## Recall Campaign 16V-071: Driver's Front Air Bag Module E82 E88 E90 E91 E92 E93

This Service Information bulletin supersedes SI B65 16 16 dated July 2017.

RE: B65 16 16 Recall 16V-071 – Driver-Side Front Air Bag Module E82 E88 E90 E91 E92 E93

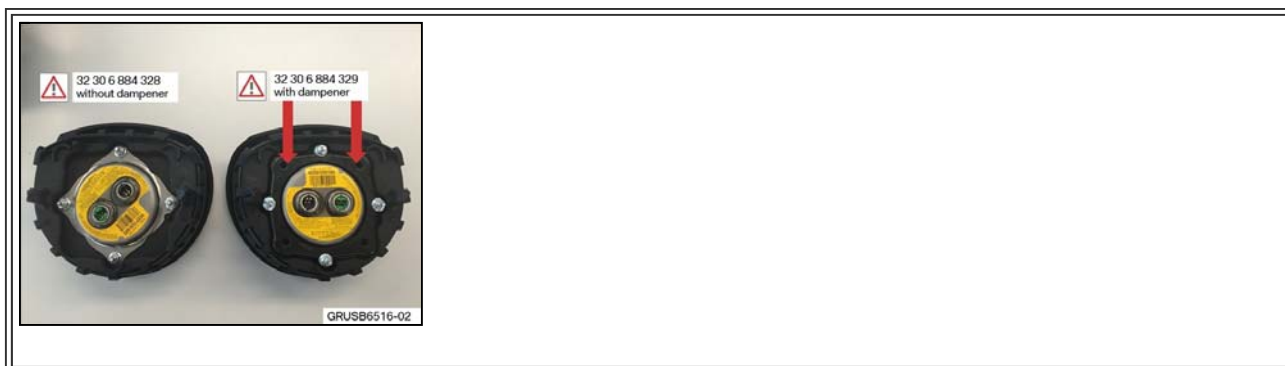
Part Number	Description	Quantity
<b>UPDATE!</b> 32 30 6 884 313	airbag module driver's side base without vibration absorber (for all E82, E88, E91 and E92) or (for all E90 and E93)	1
(Desiccated)		
or 32 30 6 884 664		
	OR	
<b>UPDATE!</b> 32 30 6 884 314	airbag module driver's side with a vibration absorber (on E90 only with engine S65 or M57Y) and ( on E93 only with engine S65 or N54T or N55)	1
(Desiccated)		
or 32 30 6 884 664

**Note: Original part coming out of the vehicle may not match the replacement part.**

**This applies to vehicles originally equipped with or without a dampener. Refer to the photos below:**
